NOTICE OF SERVICE INTERRUPTION/WORK FORM

The new soccer field irrigation system is being fed from a 3" supply line from the existing grandstand water meter room XS-105. A suggestion was made that a bypass around the hydrometer would be prudent to ensure water can still be fed to the soccer field irrigation in the event the hydrometer malfunctions or requires maintenance.

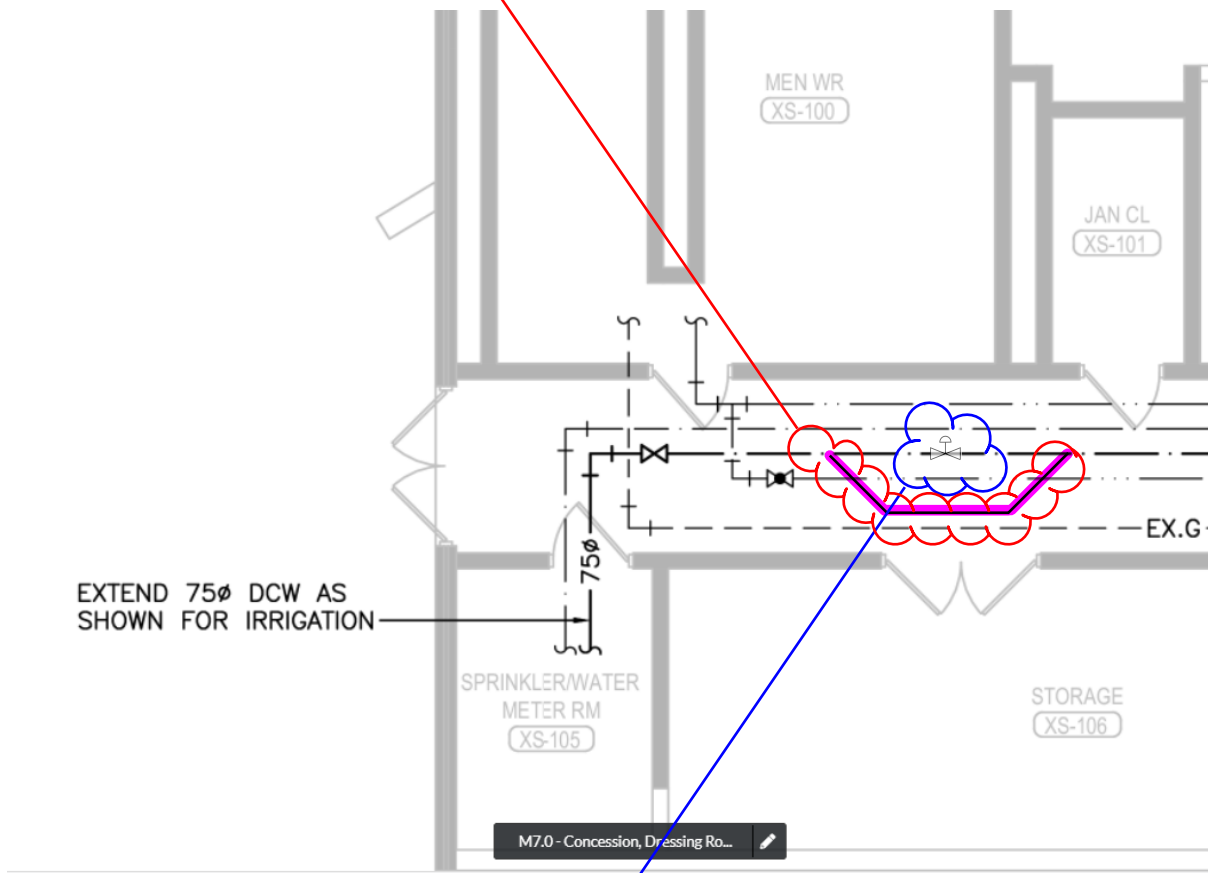
There is currently a normally open 2" hydrometer (5ft of straight 2" pipe on either side of the meter) installed within the 3" copper supply line for the soccer field irrigation beneath the grandstands.

LANDSCAPE AREA MASTER VALVE: IRRITROL 102P2, 2". CHANGE THE VALVE TO BE 'NORMALLY OPEN' BEFORE INSTALLING.

SPORTS FIELD MASTER VALVE: NETAFIM LHM2TG1-MEL-NO, 2" FTP N/O HYDROMETER
